Report on the failure of David Wilson Homes to comply with the planning permissions granted for Thurstan's Rise, Coleford:

**P1251/12/FUL,
P1167/13/FUL,
P0061/13/DISCON,
P0053/17/FUL,
P1112/19/FUL,
P0079/20/DISCON, and
P0510/20/NONMAT**

**David Wilson Homes – Thurstan's Rise – Coleford
Failure to comply with planning permission**

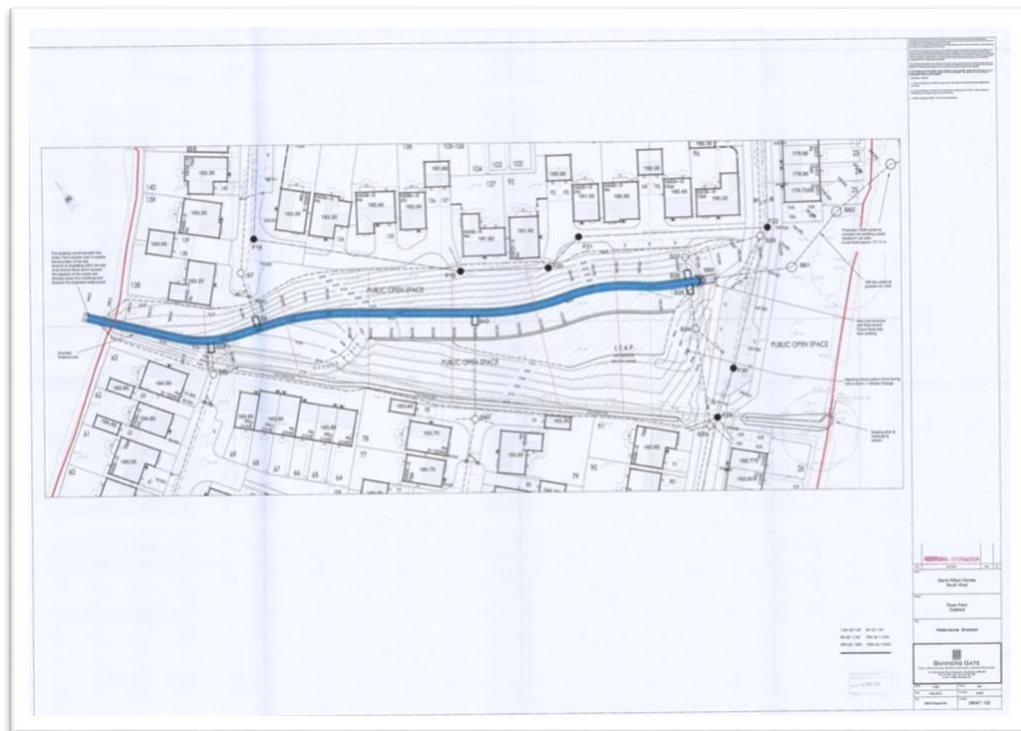
The central area of the estate contains the valley of Sluts Brook, one of three streams which join (now in underground culverts) in the centre of Coleford. This brook rises from a natural spring near Crossways, and flows across the field to the northwest of the estate before entering the central public open space between Inwood Drive and Cadora Way. For parts of the year, the brook is little more than a trickle, or completely dries.

In winter however, as well as what emerges from the spring, it forms the main drainage channel for all the surrounding fields, and can swell very quickly into a raging torrent carrying a heavy load of silt ([View video](#)).

Historically, Sluts Brook has been the cause of regular minor flooding in the neighbouring Oakfields estate. Since the building of Thurstan's Rise estate, the increased rapid run-off from hard concrete and tarmac surfaces means that water is channelled into this section of the brook much faster than it was previously. In 2015, during the building of the estate it was the cause of a major flood in Oakfields, which resulted in several vehicles in the car park there being seriously damaged. Following this incident, steps were taken to moderate the flow of the brook, to avoid sudden large volumes of water overwhelming the capacity of the culverts below Oakfields, and further downstream.

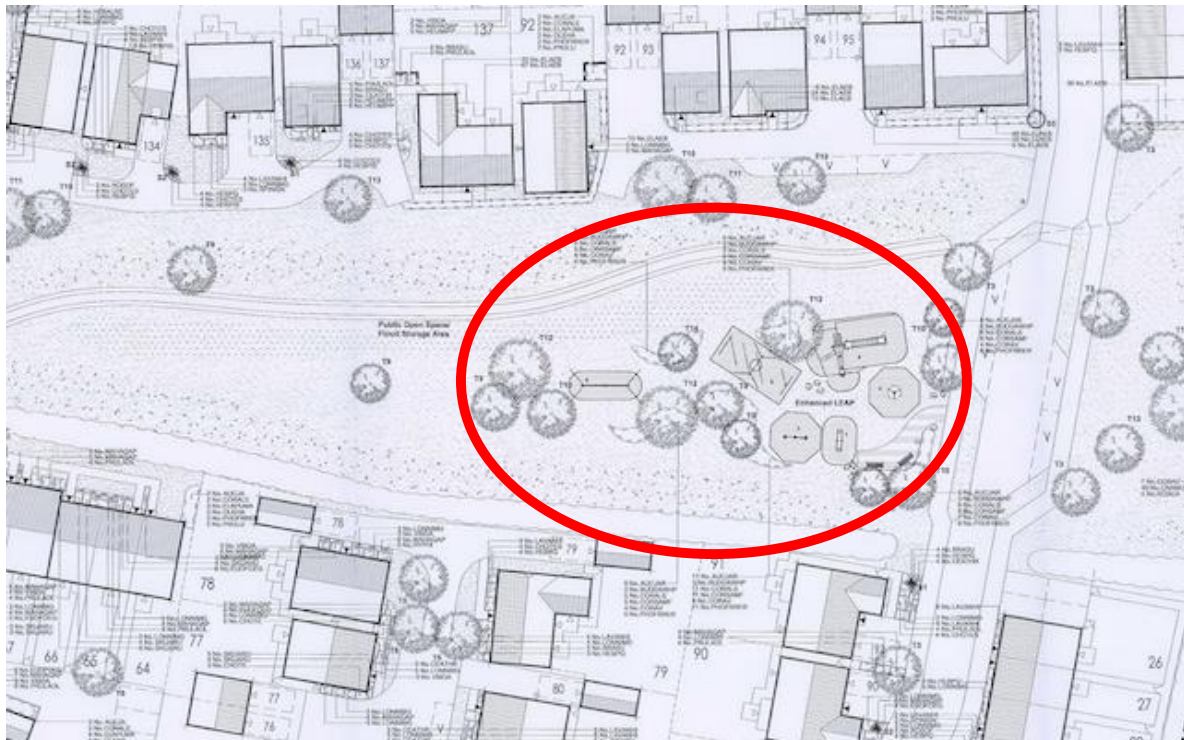
Sadly, neither the free-flowing brook nor the landscaped POS (public open space) has ever been the experience of the residents, due to the main drainage from the estate (Sluts Brook) being continually silted up, resulting in the POS being either under water, or a waste land:

Prior to the LEAP (Local Equipped Area for Play) being re-sited (planning application P1112/19/FUL), the play park spent much of its life under water:

The probable cause of this is a blockage of the orifice plate by the quantity of silt washing off the surrounding fields and into Sluts Brook.

Not only is the area now smelly, unpleasant and unsightly when not full of water, it poses a significant danger – particularly to children – when it is.

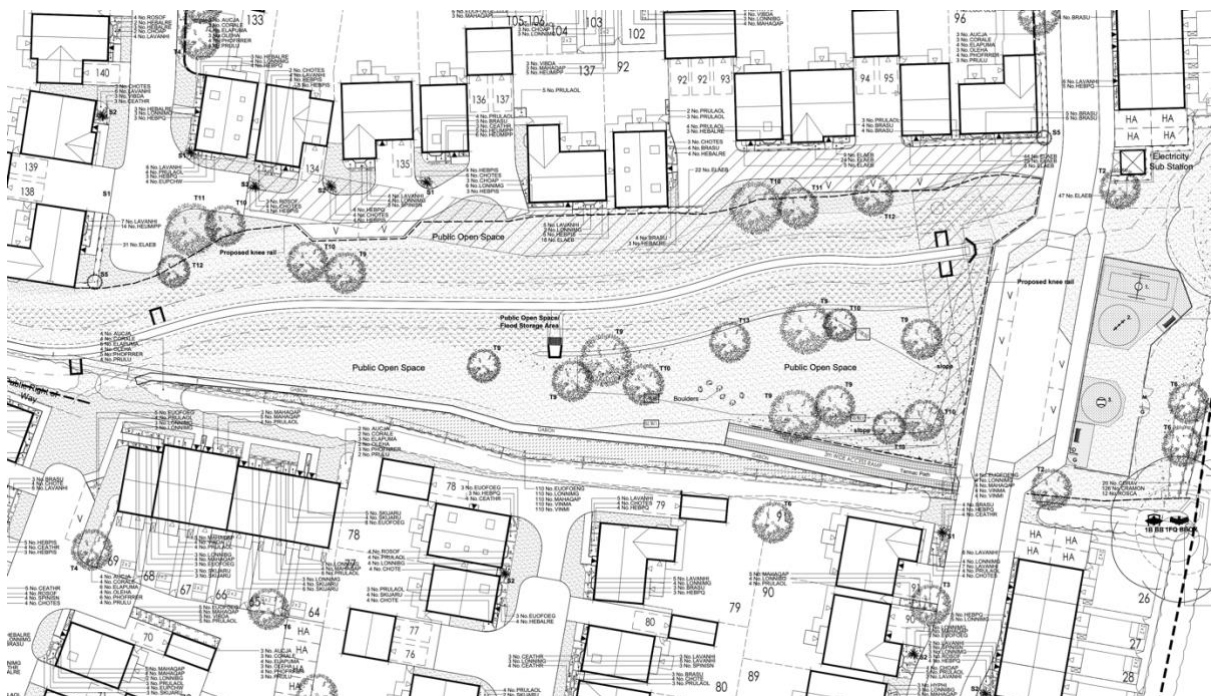
Despite numerous requests to DWH over the past four years (and many broken promises from their directors), DWH have continually failed to complete much of the landscaping across the site, as per their submitted landscaping proposals (P1251/12/FUL and P1112/19/FUL) and as specified in their most recent drawings:

The Public Open Space (currently Lake Caudwell) remains a waste land when it isn't flooded (during 6 months of the year), despite this supposedly being one of the main features of the Thurstan's Rise planning concept.

The detailed landscape proposals within P1112/19/FUL (approved on 13th February 2020) specify – *within the public open space* – a meadow mixture of wild flowers (11 varieties), meadow grasses (4 varieties), stream edge wild flowers (18 varieties), stream edge grasses (7 varieties), as well as 24 trees and 550 shrubs and bushes on top of the gabion wall to prevent soil erosion.
